**Re: Lane Cove Data Centre – summary of changes for resubmission  
Addendum Bushfire Protection Assessment, Vegetation Management Plan,  
Watercourse Assessment Report  
1 Sirius Road, Lane Cove West**

*Travers bushfire & ecology (TBE)* has been requested to provide a summary of the changes undertaken to the following reports since the previous July issue of the reports;

## bushfire protection assessment (addendum)

**Proposed Data Centre / Warehouse Distribution Centre  
Lot 1 DP 1151370  
1 Sirius Road, Lane Cove West**

**Figure 2 – Access design (new August scheme)**

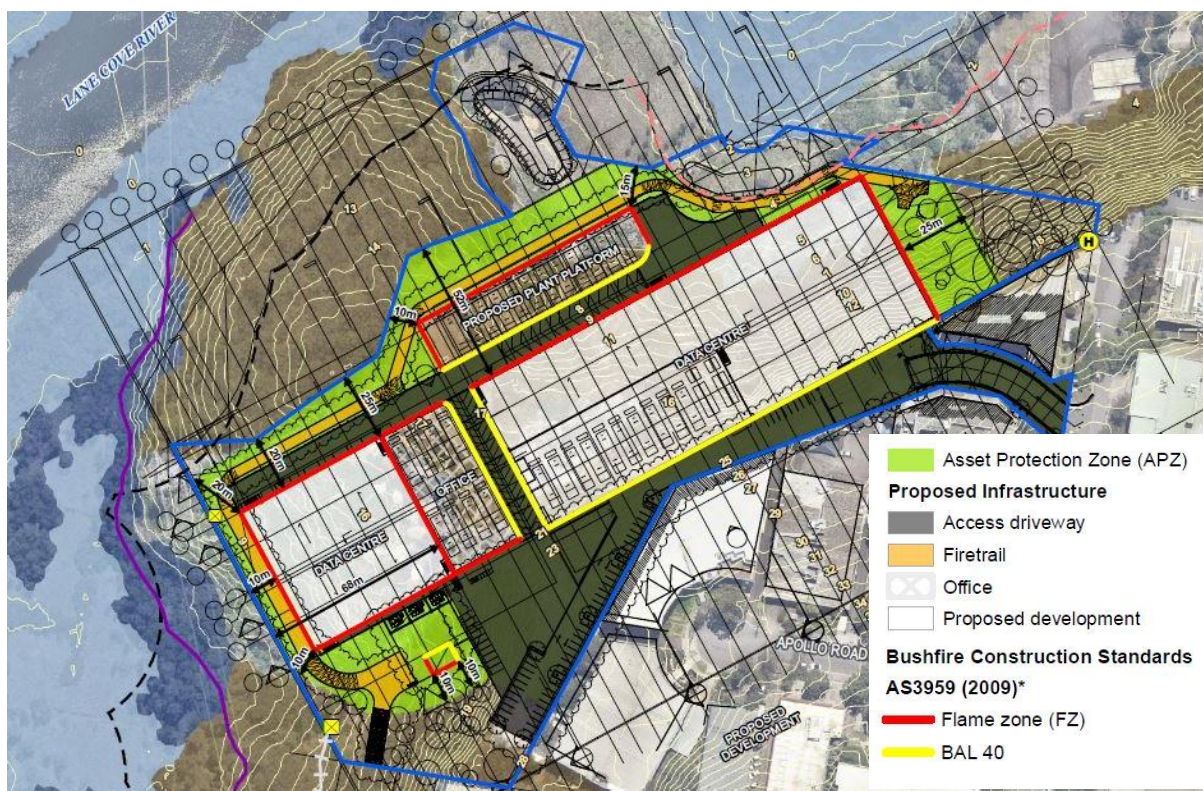
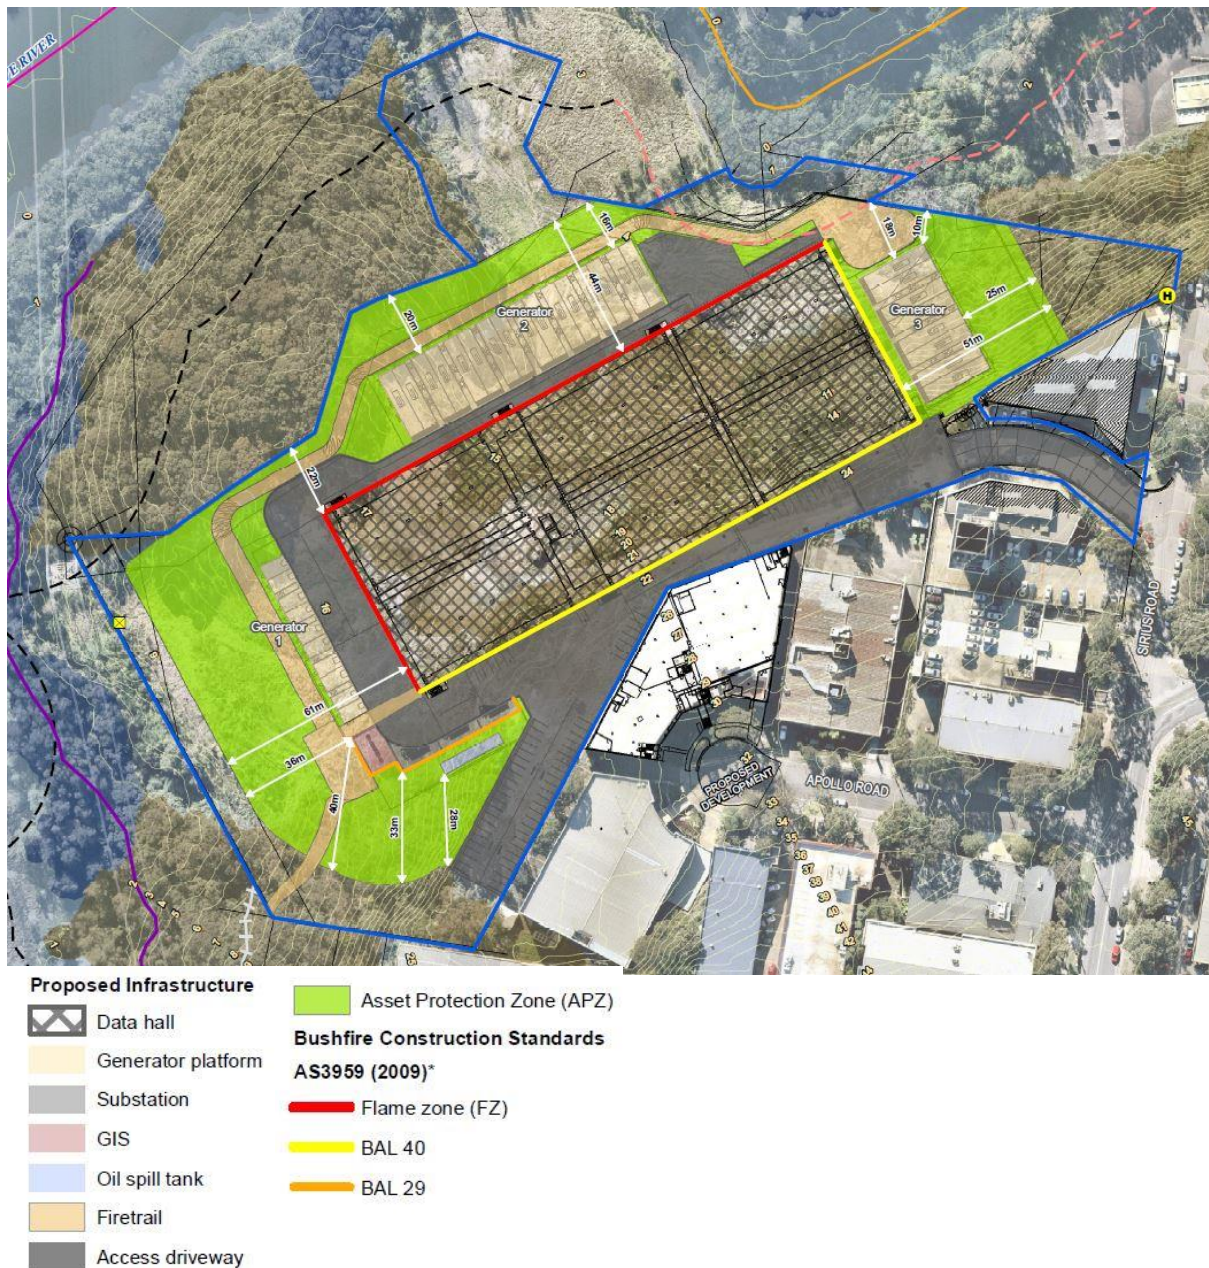
Changes to the driveway include the provision of property access road around the southern, western and northern perimeter of the data centre building. The previous design depicted an access road through the centre of the site between the office and the data centre (refer Figure 1 – access in grey)

The changes to the fire trail design are outlined in Figure 1 & 2 above. The general alignment of the fire trail in the north remains the same. The fire trail in the west now runs adjacent to the generator platform and not adjacent to the western boundary therefore allowing for the retention / regeneration of trees within the western site boundary.

Changes in terms of building construction standards are highlighted in Figures 1 & 2. Based on the amended simplified design the roof, northern and western building facades of the data centre are to comply with BAL FZ. The remaining facades can step down to BAL 40. This is consistent with the recommendations from the NSW RFS.

As outlined in the addendum bushfire report the revised scheme maintains compliance with the NSW RFS conditions for private roads. The revised scheme provides additional firefighting access and increased defendable space around the perimeter of the building therefore improving the bushfire protection measures afforded to the development.
